Subject: RV Door Latch may experience a lock-out condition

This letter serves to notify Dynamax Corporation that TriMark is intending to issue a Technical Service Bulletin and conduct a Field Retrofit for the PTL Entrance Door Model 3000 that uses a TriMark 030-0900 Motor Home Entrance Door System with a 21396-05 Inside Release.

Subject: RV Door Latch may experience a lock-out condition

Reference - Images of the existing and new designs:

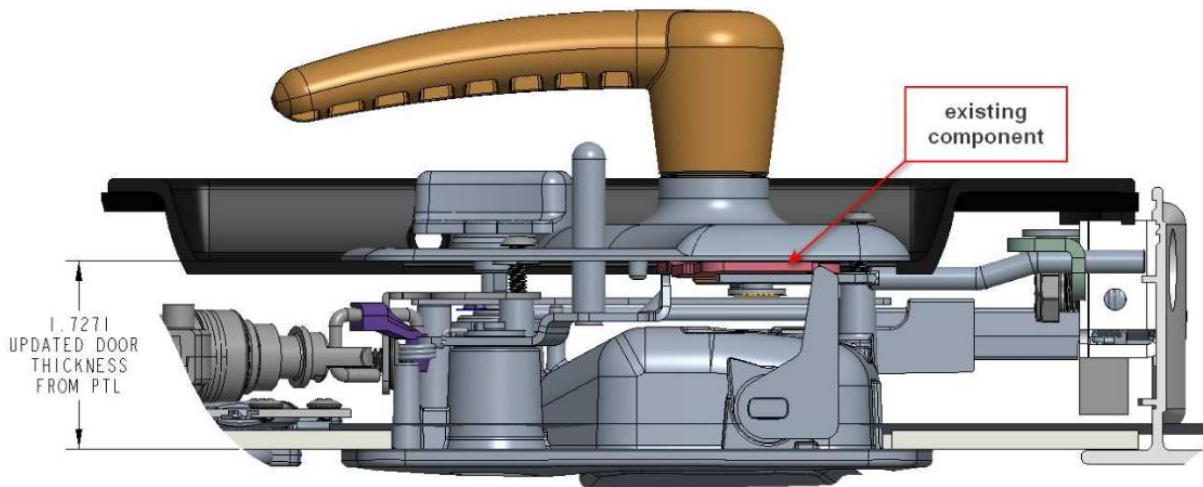
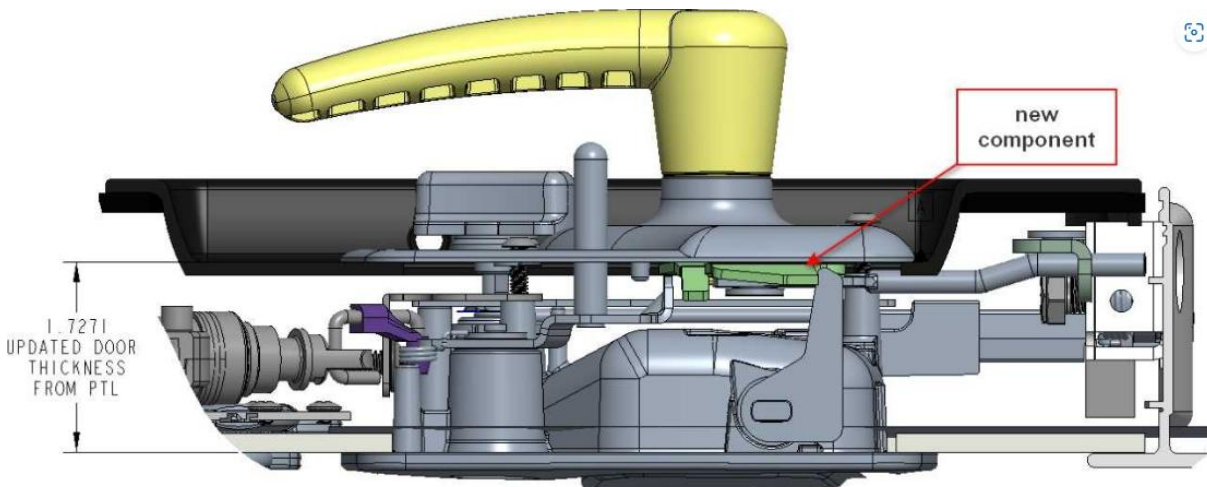
Description of the defect: TriMark manufactured and sold to PTL, a complete RV door hardware system consisting of a 030-0900 Exterior Paddle Handle (P/N's 36285-02 and 36285-04), Inside Release (P/N 21396-05) and Rotary Latch (P/N 17999-01). PTL Engineering has reported that several Motor Coach Manufacturers have encountered issues with motorhome lockouts at their manufacturing facilities. Additionally, there have been several reported lockouts affecting coach owners on sold units. It was found that the pivot arm on the outside handle may pass underneath the release arm of the inside handle, due to multiple potential root causes preventing the door from opening from the outside handle. However, the interior handle is still operational from inside of the motor home.

Description of the safety risk: a small percentage of doors exhibit a condition where the exterior paddle handle can bypass the inside release pivot causing a lock-out situation, but the door can still be opened from the inside.

Description of program for remedying the defect: TriMark has redesigned the inside release pivot plate to provide more engagement with the pivot arm for PTL Entrance Door Model 3000. PTL has modified the bracket to accommodate with the new hardware. This product update will retrofit with the current exterior paddle handle for the field campaign as well as ongoing production. A manufacturing mark will be included on the adjustment rod of the Inside Release Assembly to serve as a visual indicator of revised Product for field identification.

Reference - Images of the existing and new designs:

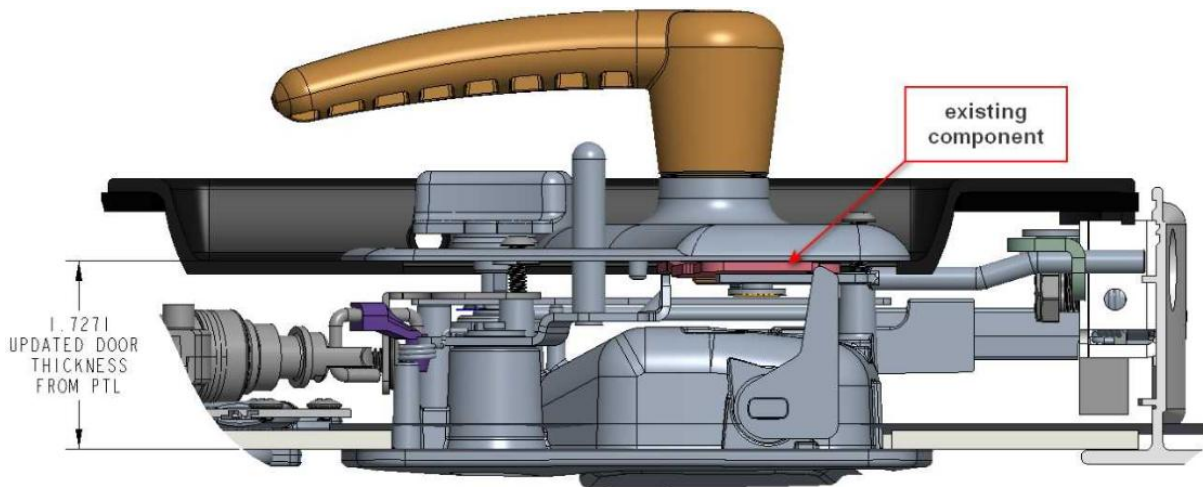
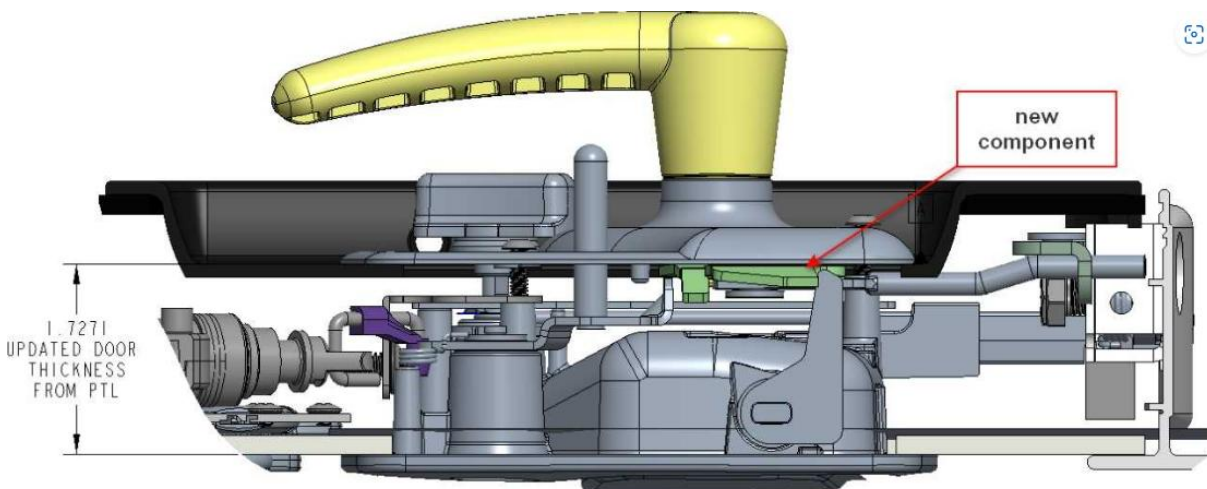
Description of the defect: TriMark manufactured and sold to PTL, a complete RV door hardware system consisting of a 030-0900 Exterior Paddle Handle (P/N's 36285-02 and 36285-04), Inside Release (P/N 21396-05) and Rotary Latch (P/N 17999-01). PTL Engineering has reported that several Motor Coach Manufacturers have encountered issues with motorhome lockouts at their manufacturing facilities. Additionally, there have been several reported lockouts affecting coach owners on sold units. It was found that the pivot arm on the outside handle may pass underneath the release arm of the inside handle, due to multiple potential root causes preventing the door from opening from the outside handle. However, the interior handle is still operational from inside of the motor home.

Description of the safety risk: a small percentage of doors exhibit a condition where the exterior paddle handle can bypass the inside release pivot causing a lock-out situation, but the door can still be opened from the inside.

Description of program for remedying the defect: TriMark has redesigned the inside release pivot plate to provide more engagement with the pivot arm for PTL Entrance Door Model 3000. PTL has modified the bracket to accommodate with the new hardware. This product update will retrofit with the current exterior paddle handle for the field campaign as well as ongoing production. A manufacturing mark will be included on the adjustment rod of the Inside Release Assembly to serve as a visual indicator of revised Product for field identification.
